**15. C. Final Plat**

[Southern Land Company - Westhaven - Lakefront Subdivision Plat - PRELIMINARY 12.06.2018.pdf](#)

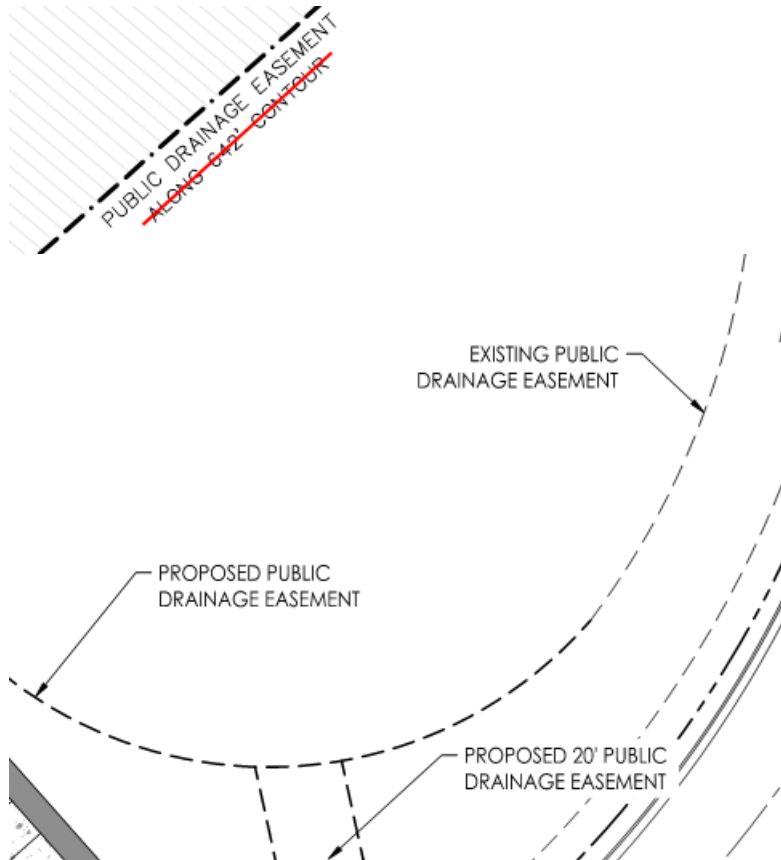
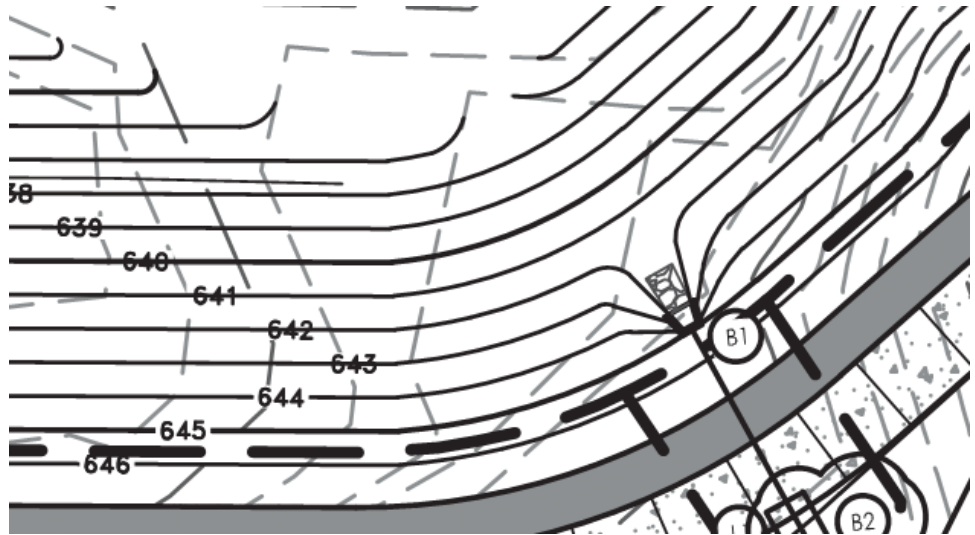
Multiple easements shown on the previous plat encroach into the buildable lot areas proposed for the revised plat and must be abandoned. Two examples appear in the overlay pasted below (current plat in red, previous plat in green):

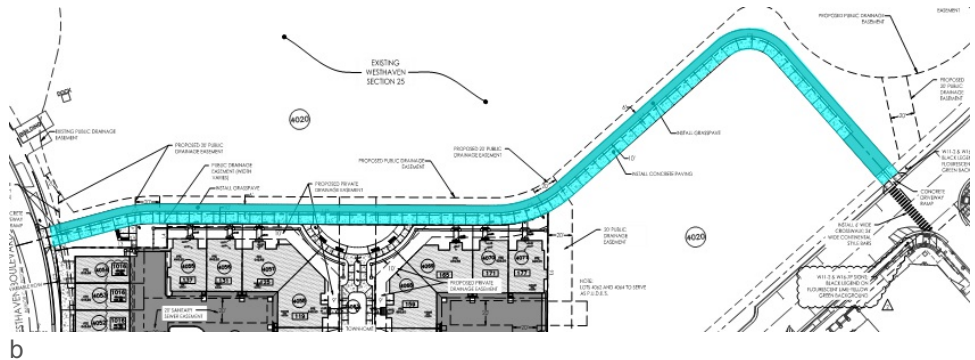
[lance.fittro@franklintn.gov](mailto:lance.fittro@franklintn.gov) Applicant shall provide Emergency Access Easement for the 10' sidewalk and 6' grasspave section (16' total easement width) that loops around the lake side of the condos and future retail portion of the development (highlighted in blue in the below snippet from the site plan).

### 18. Plat Note

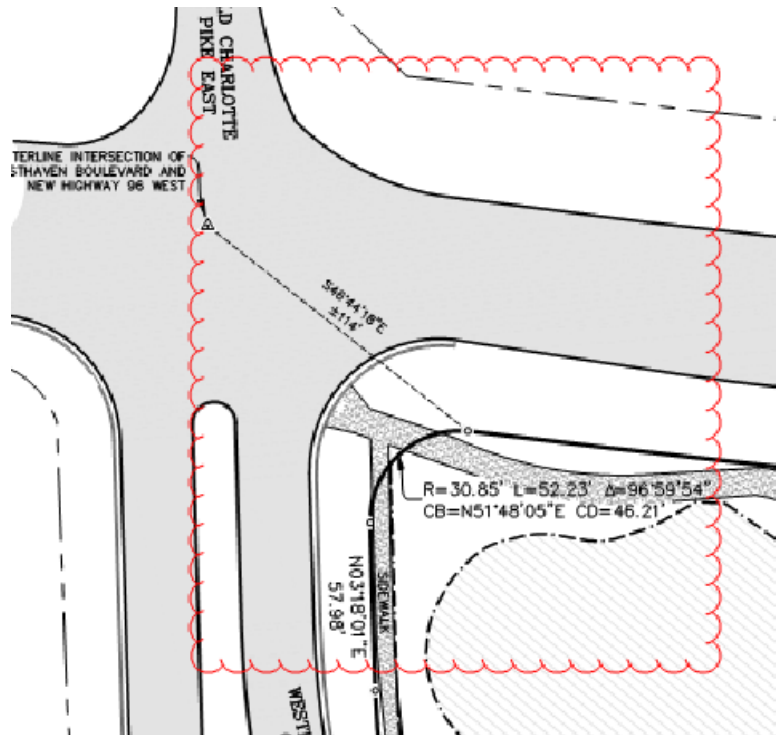
christopher.andrews@franklinton.gov Minor revisions for spelling errors to be corrected before One Stop approval:

Surveyor note 14:

"WITH" presumably changed to "WILL"

Ownership note:

"TIME" presumably changed to "TIM"

### 4. Sanitary sewer

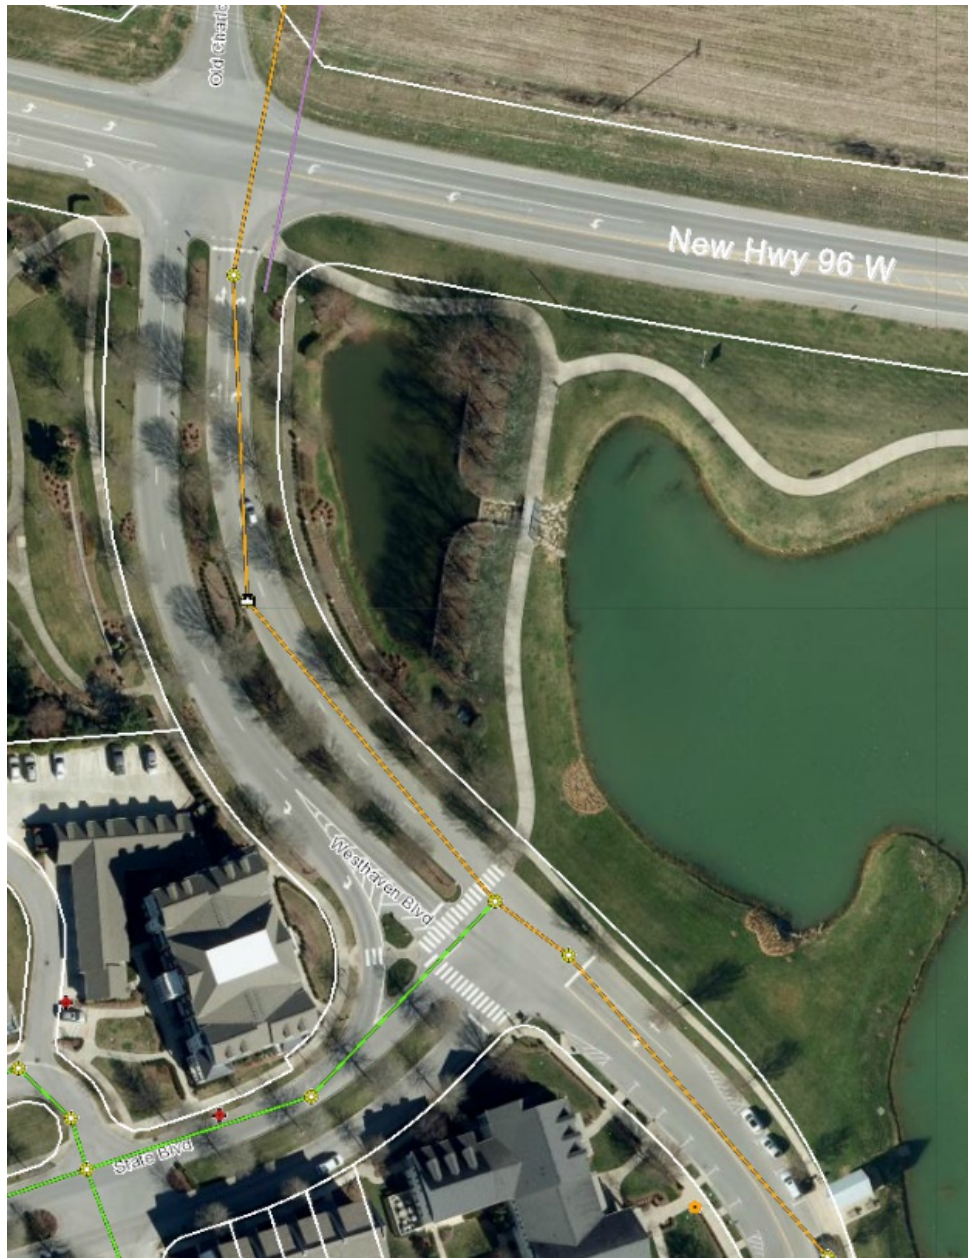
[ben.mcneil@franklin.tn.gov](mailto:ben.mcneil@franklin.tn.gov) The applicant failed to address the issue, the applicant shall provide the location of all existing sanitary sewer on the proposed plat. The areas along Westhaven Blvd do not show the existing sanitary sewer. The GIS information is provided below, but is not intended for the applicant to use this information. The applicant shall physically locate the utilities for platting.
